October 29, 2021

ADDENDUM # 3
Little Hills Expressway and Mel Wetter Parkway Intersection Improvements
PROJECT NUMBER CMAQ #4917(602)
BID # 4527

The City of St. Charles is issuing this Addendum to the Little Hills Expressway and Mel Wetter Parkway Intersection Improvement Plan Sheets and Bid Documents. The purpose of the addendum is to make modifications to the stamped brick median, traffic control plans, sign posts, and the MSE wall. The revised bid information is as follows:

SHEET NO.: 3

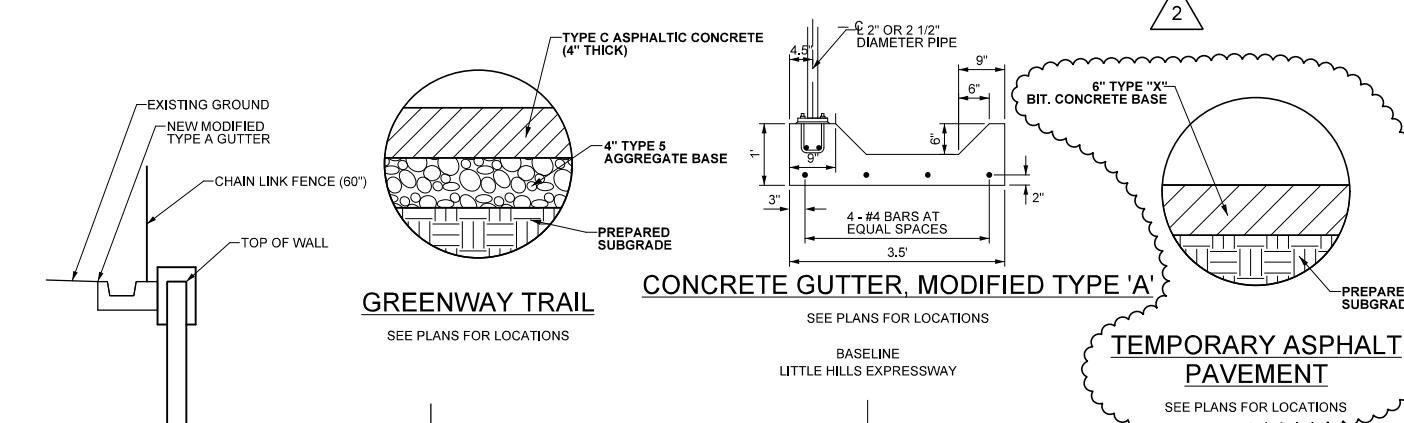
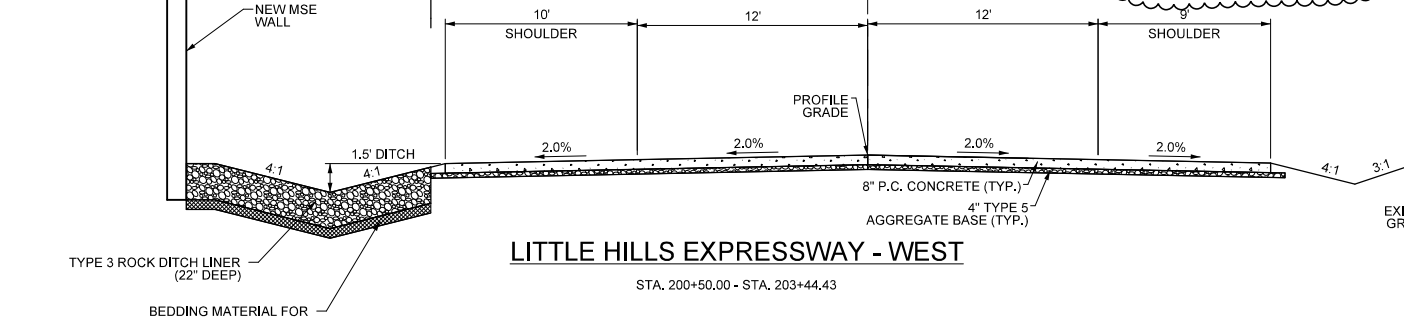
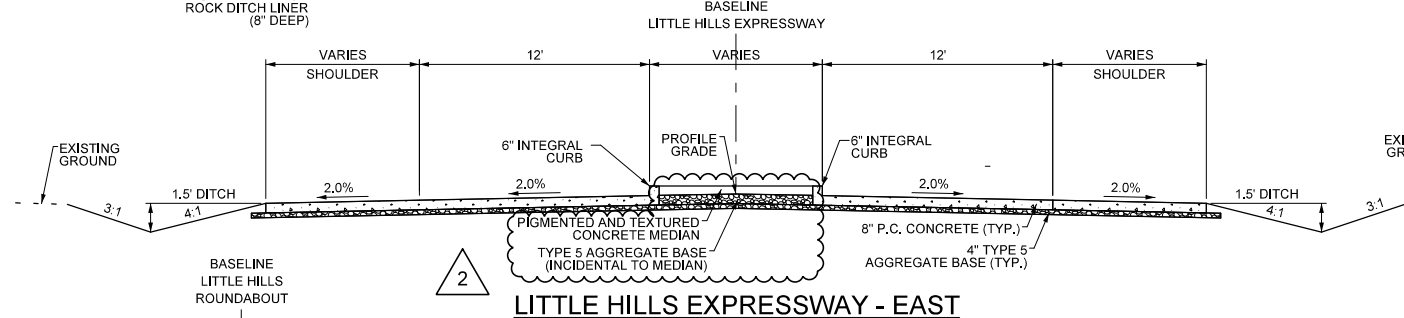
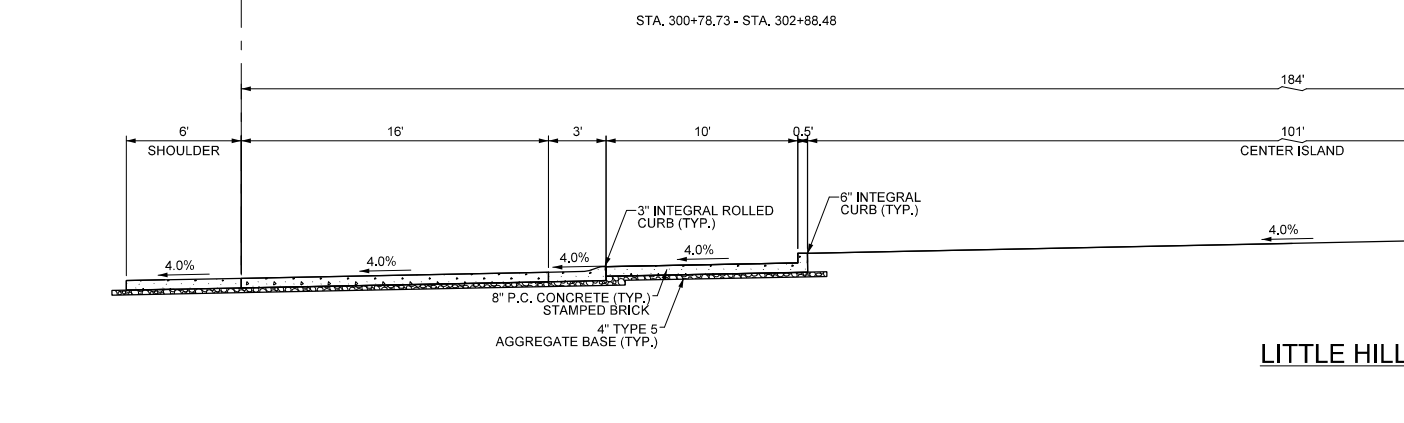
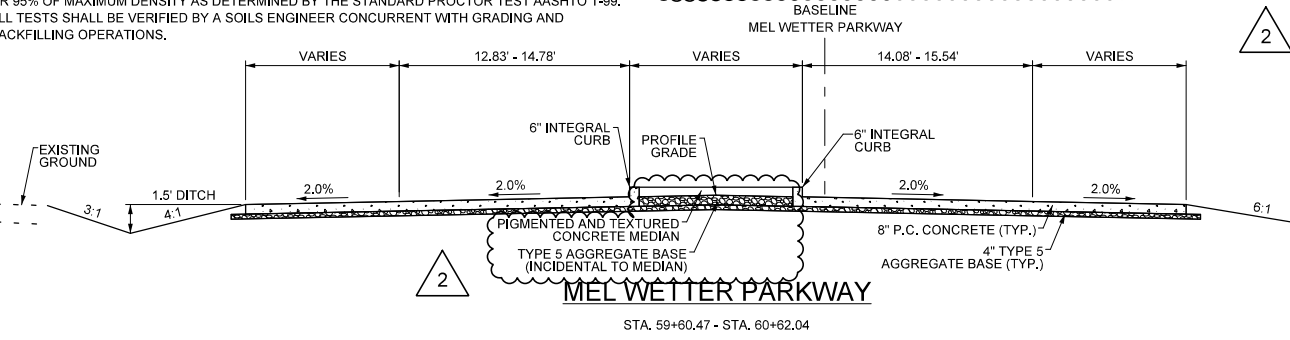
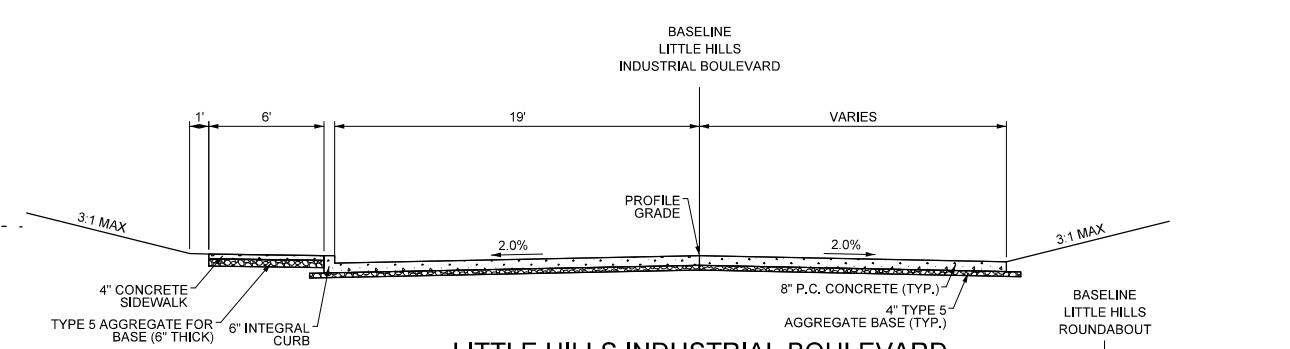
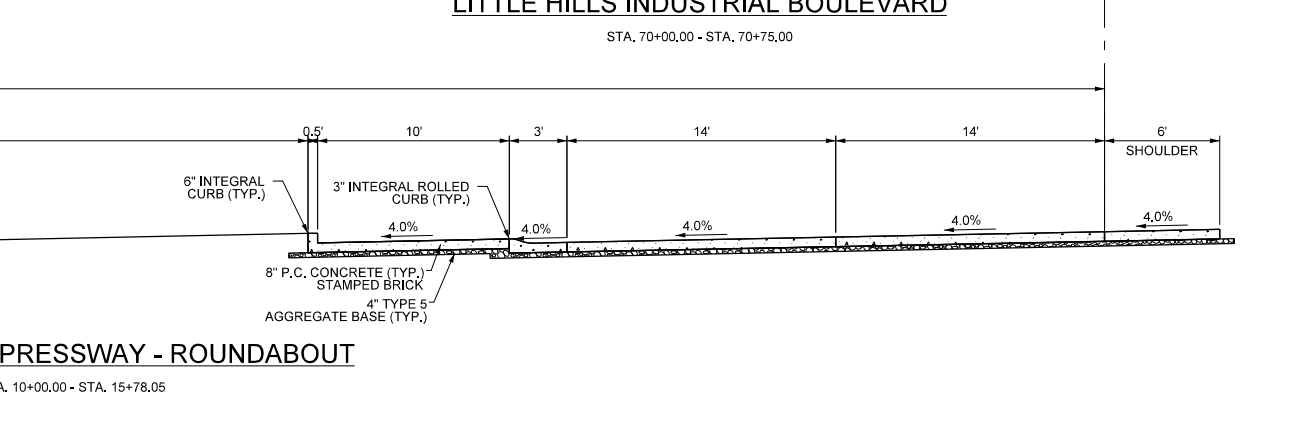
1. On the plan sheet #3, the typical section for the median has changed to clarify that Type 5 Aggregate is incidental to the median. The call out for “Stamped Brick Median” has changed to “Pigmented and Textured Median” to match the bid item.

- c. A temporary asphalt pavement detail has been added to plan sheet #3.
3. On plan sheet #20, general note #2 removed ornamental with square tube posts. Also, an extra note #4 was added, stating, “Wayfinding signs shall be mounted on two sign post each”.

LITTLE HILLS
EXPRESSWAY
TRAFFIC CONTROL PLAN
PHASE 1
SHEET 2 OF 2

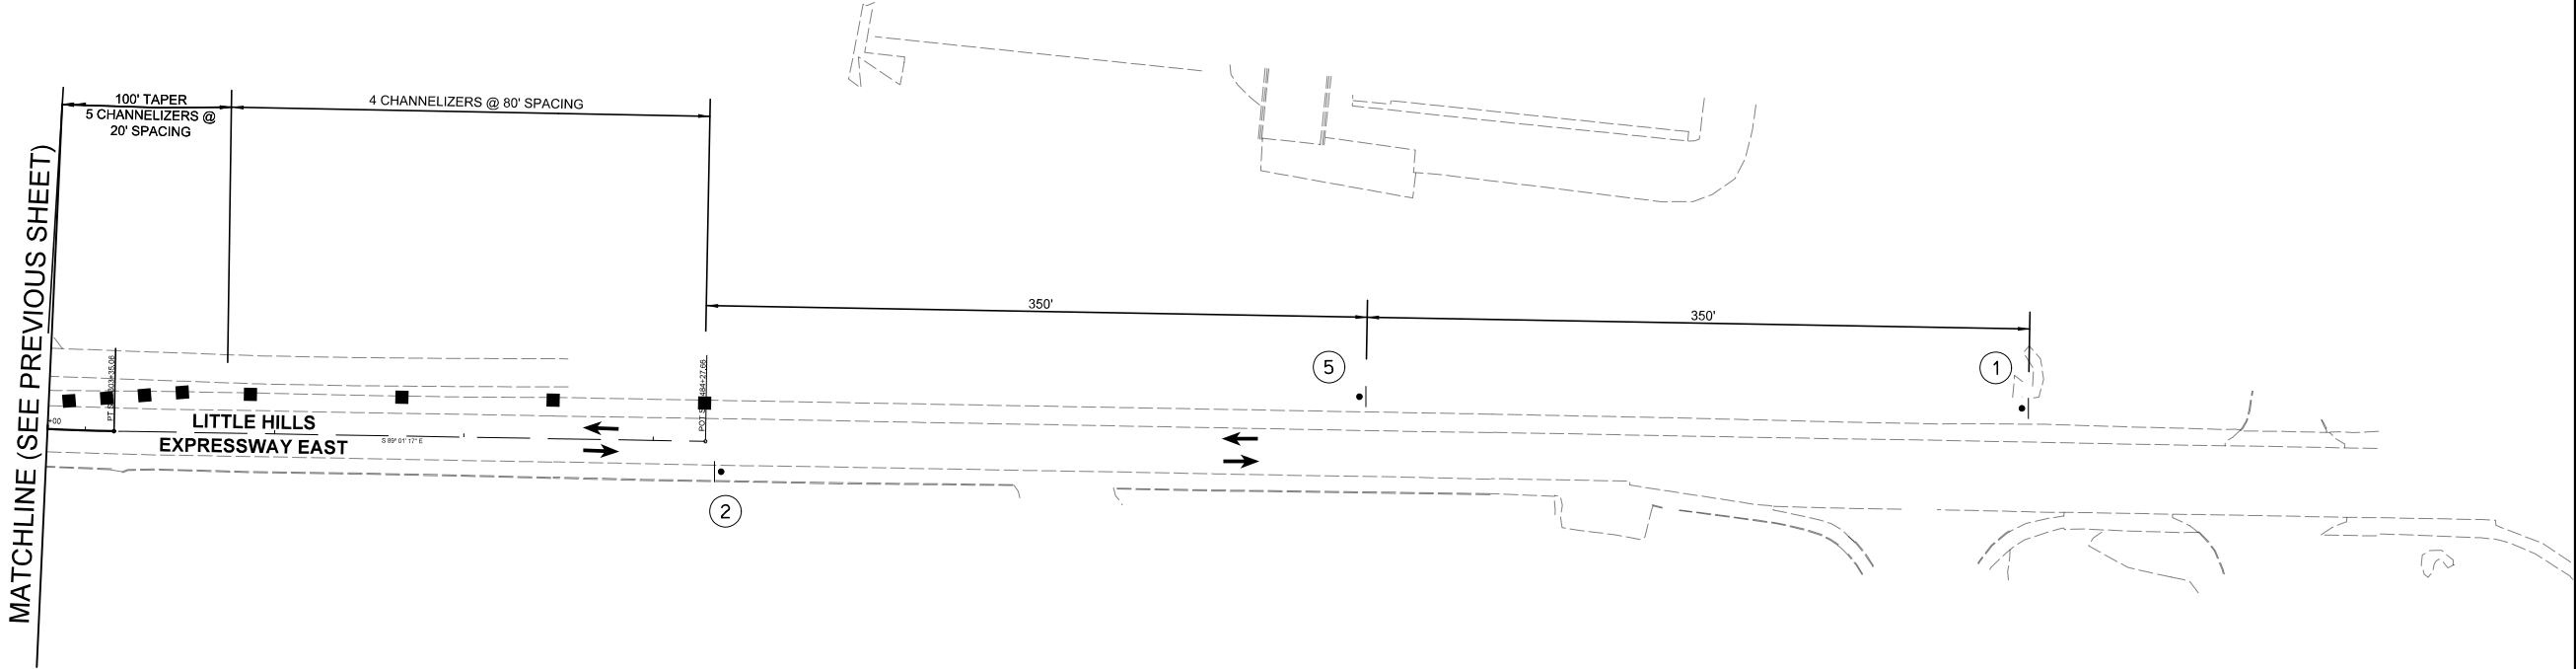
2. On plan sheets #12-16, the traffic control plan for phase 1 & 2 changed. Phase 1 added a quality for temporary asphalt on the east and west ends of the roundabout in order to shift westbound traffic into the roundabout for phase 2. Phase 2 plan sheets shows the necessary traffic control to navigate westbound drivers to utilize the northern portion of the roundabout.

- a. JSP B – Work Zone Traffic Management Plan section 4.2-4.2.2 have been revised to reflect these modifications.
 - b. Plan Sheets 2A, 2B and #11 have been updated.

DISTRICT: SHEET NO.: 24

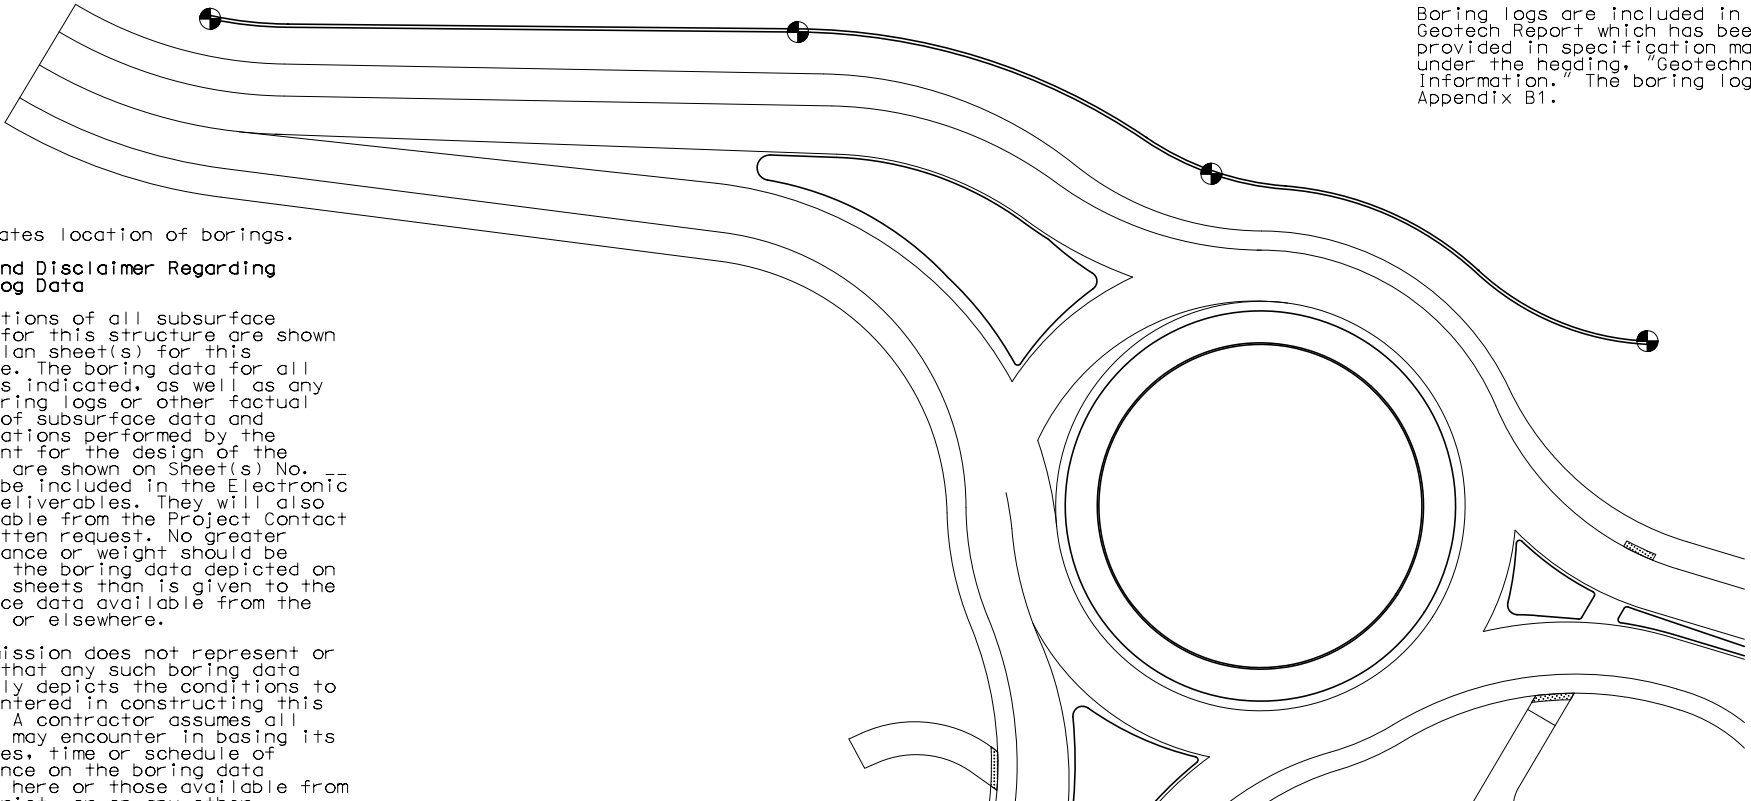
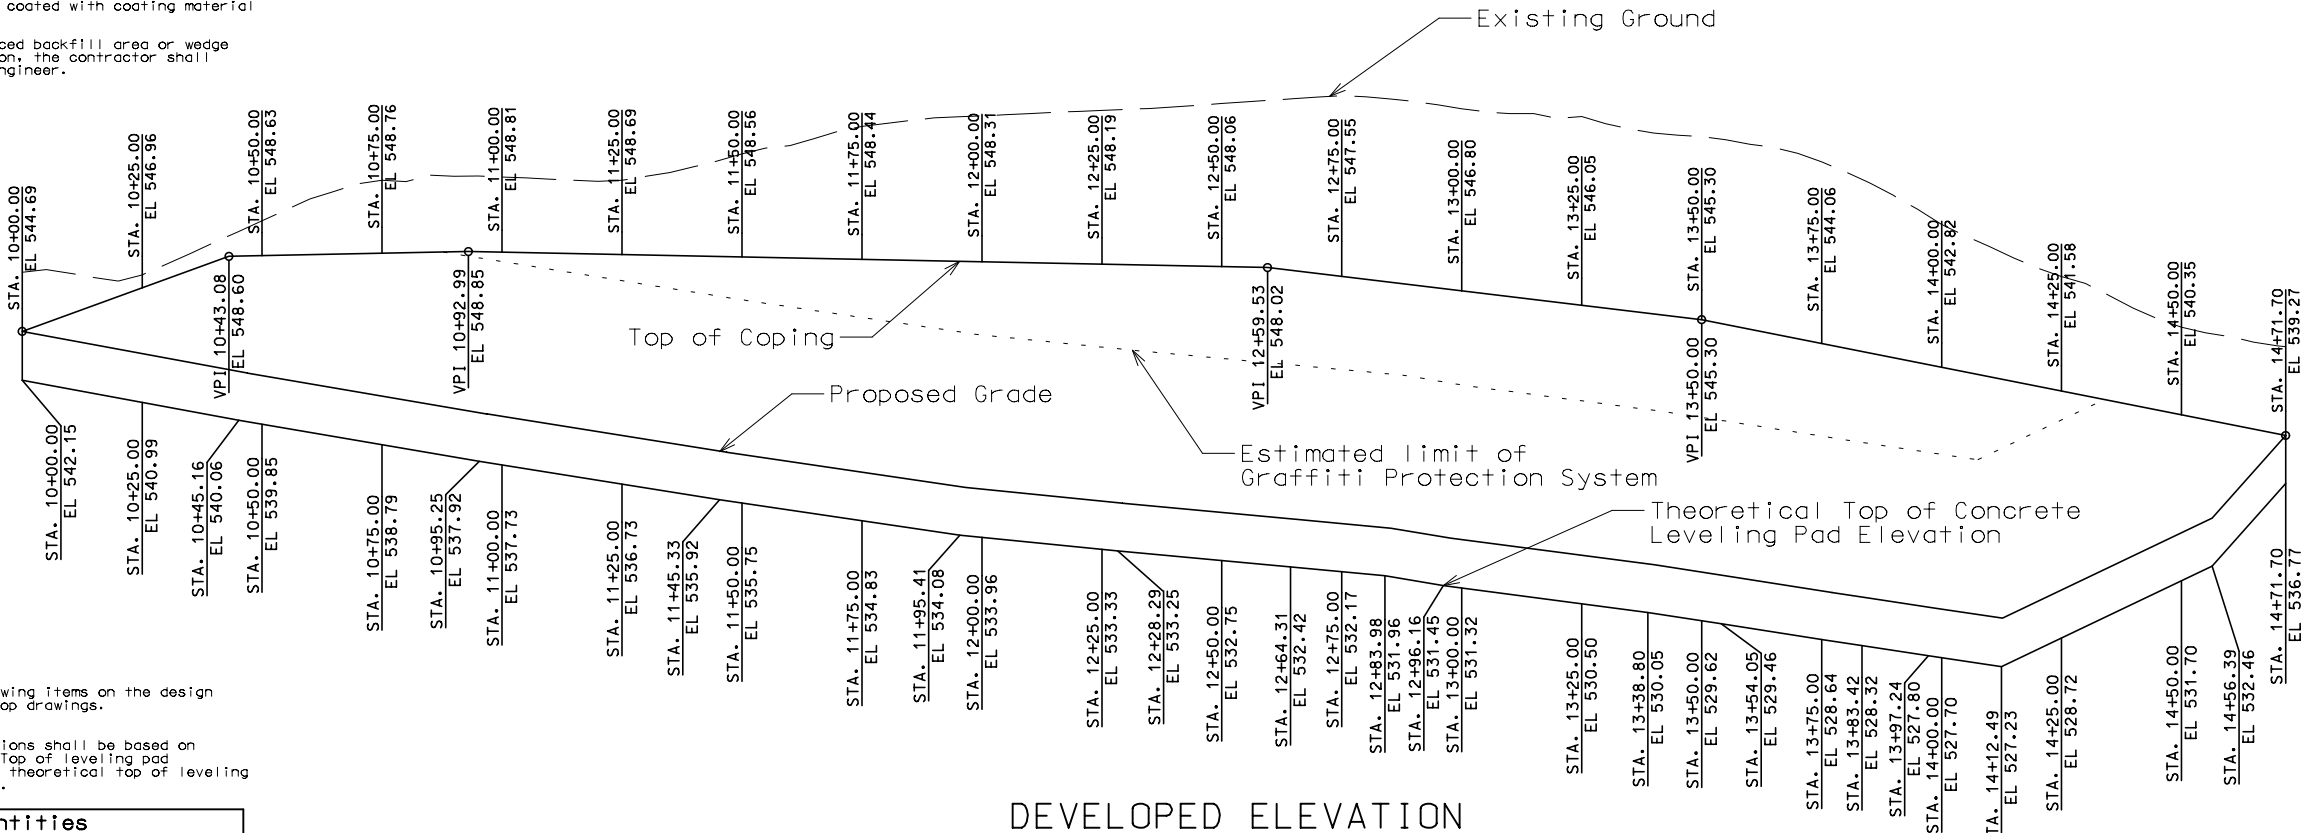
4. On plan sheet #24, the mechanically stabilized earth (MSE) wall height was shortened which reduced the MSE quantity from 8,802 to 5,894 SQFT. Soil reinforcement length changed from .7H to 1.0H which is shown on plan sheet #25.
 - a. Plan Sheets #2A, #2B, #4, #5, Cross section sheets #36 & 37, and the Report of Subsurface Exploration and Geotechnical Engineering have been updated.
5. The Project Bid Form has been revised to accommodate these changes.
